**CITY OF SACRAMENTO  
DEPARTMENT OF PLANNING & DEVELOPMENT  
ZONING ADMINISTRATOR  
1231 I Street, Sacramento, CA 95814**

**ACTION OF THE ZONING ADMINISTRATOR**

On Wednesday, June 9, 1999, the Zoning Administrator approved with conditions a Plan Review Modification (File Z99-033). Findings of Fact and Conditions of Approval for the project are listed on pages 3-6.

Request: **Zoning Administrator Plan Review** to construct a 4,500 square foot industrial building on 0.85± vacant acres in the Light Industrial-Review (M-1S-R) zone.

SITE PLAN  
SITE DETAILS

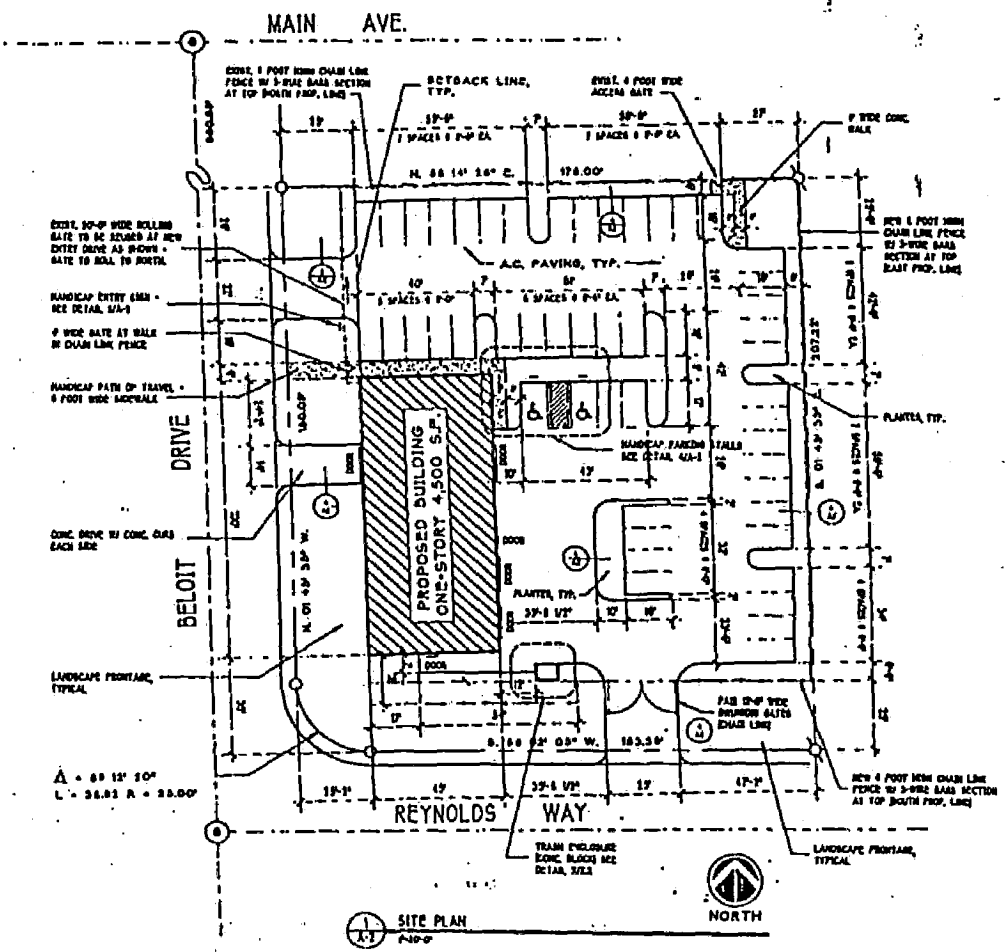
The proposed site plan indicates the site has adequate access, maneuvering, and parking. The proposed project meets all setback requirements. The trash enclosure will be located in the southwest corner of the parcel. The trash enclosure must provide adequate space for 2 cubic yards of volume (1 cubic yard/3000 square feet) and conform to the requirements of the Zoning Ordinance.

The Ordinance requires 9 parking spaces for industrial uses. The site plan provides 49 parking spaces which exceeds the requirement. This number includes two handicap accessible spaces and provides for at least one van parking. The purpose of this project is to provide a secure paved area for the company's service fleet. The parking spaces are 16 feet in length; the additional 2 feet are a part of the vehicle overhang space included in the 6 foot landscaped area. All of the parking spaces have been provided with the minimum 8 foot stall width requirement. The project is required to provide two bicycle parking spaces; one Class I, the second may be Class I, II, or III.

6. Two bicycle parking spaces shall be provided on site and at least one shall be a Class 1 facility. The location of the bicycle parking spaces shall be provided on a revised site plan at the time plans are submitted for permit.

EXTERIOR ELEVATIONS  
SECTIONS

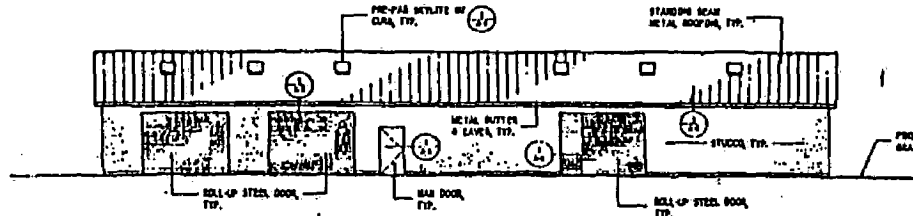
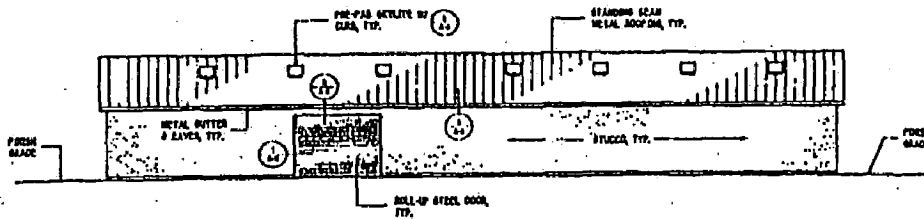
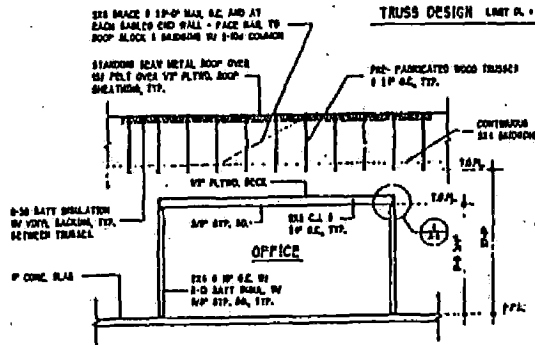
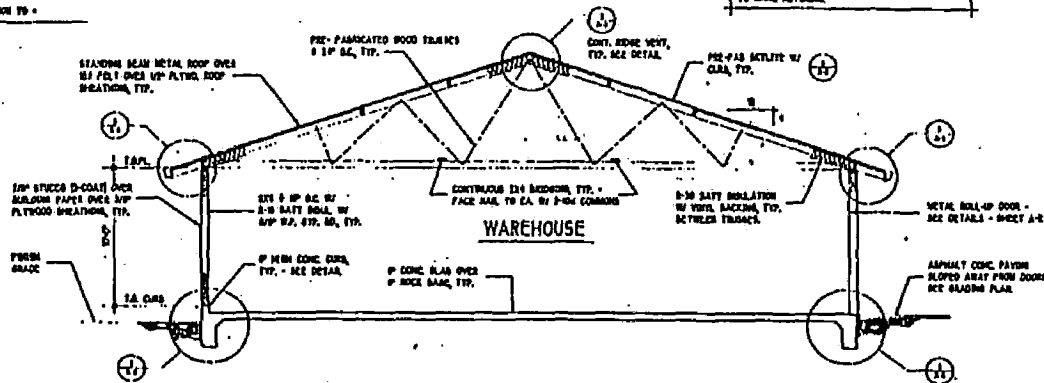
The structure was originally proposed to be single story with a stucco finish, standing seam metal roof with pre-fab skylites, and circular metal gable end vents. The main Clark Building has, however, a tile roof. The applicant agreed to revise the roof material to concrete tile to be compatible with the existing building. The new building will be painted white to match the existing building.

7. All signage shall have a sign permit and meet the requirements of the Sign Ordinance.
8. The roofing material shall be revised to reflect a concrete tile roof, color to match the existing building. (It is noted that the new roof will not match the existing tile roof exactly, but will be a product very similar to the existing roof.)
